Subject: RE: Urgent Review

**Subject:** Urgent Review

Thank you for the opportunity to discuss my concerns, regarding the current plan for sidewalk construction at 303 N. Washington Avenue, earlier today. Our conversation highlighted the importance of addressing potential issues with future building modifications, particularly the need to avoid pouring city sidewalk concrete directly over the existing structures and property line without a break.

Expansion breaks at neighboring property lines.

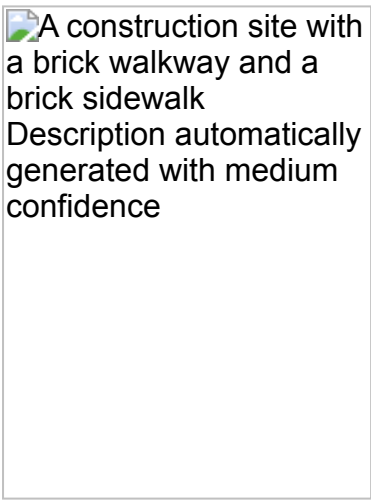
Upon reviewing the photos I took this evening, it's evident that an expansion joint or break is being installed between the existing buildings and the new sidewalk along both sides of the

However, at 303 N. Washington Avenue, I observed that the sidewalk extends beyond what appears to be the property line without a break. Considering our discussion about future plans to straighten the building's front and eliminate offsets, installing a break at the property line at this point seems prudent.

303 N. Washington Avenue, today's site preparation to pour over the property line without a break at the property line. (Additionally, the footer was covered with dirt.)

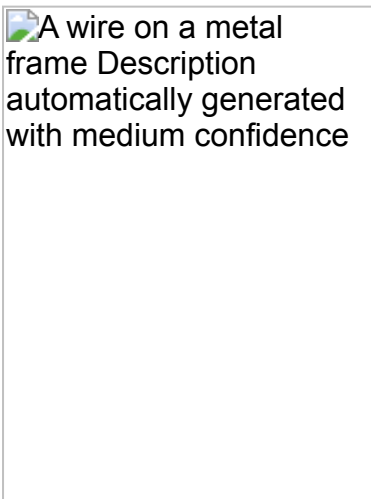
I understand your perspective that the sidewalk could be cut in the future to accommodate any necessary modifications, such as installing a footer etc. However, upon closer inspection, I uncovered the original footer beneath the area we previously discussed as the likely property line. Pouring dirt and concrete over this existing footer, especially with impending changes to the building's structure, could present significant challenges during future renovations, and unnecessary cutting and demo of a portion of the new sidewalk.

Given the confirmation of the existing footer's alignment with neighboring storefronts, I respectfully request a reconsideration of the decision to extend the sidewalk beyond this point without a break. Stopping the current pour at the edge of the footer would facilitate a cleaner installation and allow for seamless modifications to the property in the future without compromising the sidewalk.

The modifications to do this would simply require cutting one piece of rebar, 1 piece of expansion board, and installing approximately 2' of form board along the edge of the footer. The contractor is welcome to anchor the form board to the building's floor joist for an easier and quicker install if needed.

1. We don't know exactly where any of the buildings property lines are and assuming it is where a footer is found is not a confirmation of that
2. The project in its most basic form is to replace the existing sidewalk in its entirety to where it was prior to any demolition. That is what is intended.
3. Yes, while having to remove any existing concrete either now or in the future does present an added effort it is not impossible to do and occurs all the time in a downtown setting.
4. It would be impossible for the City and its contractor to be able to anticipate what any building owner either now or in the future would want to do with the front of their buildings.

If it is your desire to have the new concrete stop short of the new footing and leave that area along your building open while you pursue any changes I will need that in writing stating that this

is your intention and that once said sidewalk pour is complete that you will accept full responsibility for anything that may occur in this area moving forward which would include you pouring concrete in these areas once you have completed the renovations to your building. Short of me receiving that signed letter of intent we will replace the existing concrete with new concrete to all extents where the original sidewalk was located at the front of all buildings.
